ANN ARBOR HISTORIC DISTRICT COMMISSION

Staff Report

ADDRESS: 710 East Ann Street, Application Number HDC12-230

DISTRICT: Old Fourth Ward Historic District

Front View

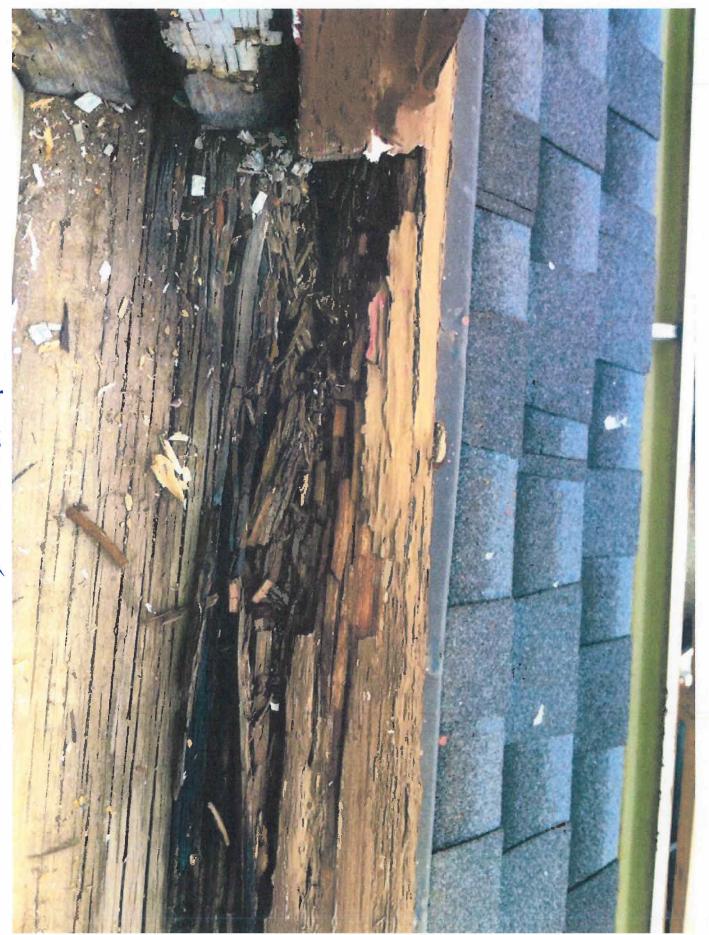
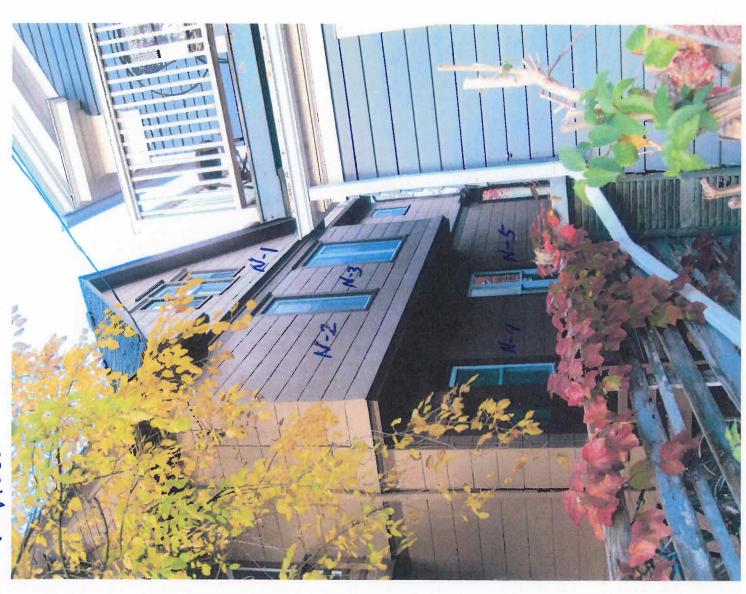
- 1. The property owners met with staff on October 19, 2012 to discuss the window situation, and a follow-up letter was sent to the owners on October 26 (see attached) explaining steps to take to bring an application to the HDC for consideration.
- 2. Per a window schedule provided by the applicants, and the staff modifications listed below, eleven of the windows replaced were vinyl, nine were wood, and three were aluminum. The schedule says window N-9 was wood and not replaced, but a photo provided clearly shows a vinyl window. Another window, F-3 on the front elevation, appears very clearly to be wood in the "before" photo provided, but the schedule says it

- 5. The replacement of a single double-hung window with a pair of double-hung windows in the same original opening is not appropriate, as was done on windows F-5, F-6, S-7, S-10, N-3 and N-5. The owner explained that this was done because of cost constraints to put in such a large sized window, and because the house has shifted and the opening is no longer square.

I move that the Commission issue a certificate of appropriateness for the portion of the application at 710 East Ann Street, a contributing property in the Old Fourth Ward Historic District, to replace windows F-4, F-5, S-1, S-4, S-6, S-7, S-8, S-11, S-12, N-2, N-4, N-7, B-1, and B-2 with vinyl one-over-one double-hung windows, provided the following conditions are met: windows F-5 and S-7 must be replaced with a single window, not a pair, in the original opening. Further, per section 8:421 of Ann Arbor City Code, the work on windows F-5 and S-7 must be completed and pass city inspection within eight months. The work as conditioned is compatible in exterior design, arrangement, texture, material and relationship to the rest of the building and the

I move that the Commission issue a certificate of appropriateness for the portion of the application at 710 East Ann Street, and contributing property in the Old Fourth Ward Historic District, to replace wood windows F-3, F-6, S-3, S-9, S-10, N-3, N-5, N-6, and N-9 with one-over-one double-hung vinyl windows, as proposed. The work is compatible in exterior design, arrangement, texture, material and relationship to the rest of the building and the surrounding area and meets *The City of Ann Arbor Design Guidelines for Historic Districts*, and *The Secretary of the Interior's Standards for Rehabilitation* and *Guidelines for Rehabilitating Historic Buildings*, in particular standard 6 and the guidelines for windows.

I move that because this work was done without permission of the Commission and does not qualify for a certificate of appropriateness, the property owner is ordered to restore windows F-3, F-6, S-3, S-9, S-10, N-3, N-5, N-6, and N-9 to their prior condition, or to modify the windows so that they would qualify for a certificate of appropriateness, consistent with section 8:421 of Ann Arbor City Code, by replacing the windows with wood windows, under the following conditions: the owners must apply for and receive a staff approval for the proposed replacement windows before building permits are issued, and windows F-6, S-10, N-3 and N-5 must be replaced with a single window, not a pair, in the original opening. The windows must be restored to their prior conditions or replaced as stated by July 10, 2013.
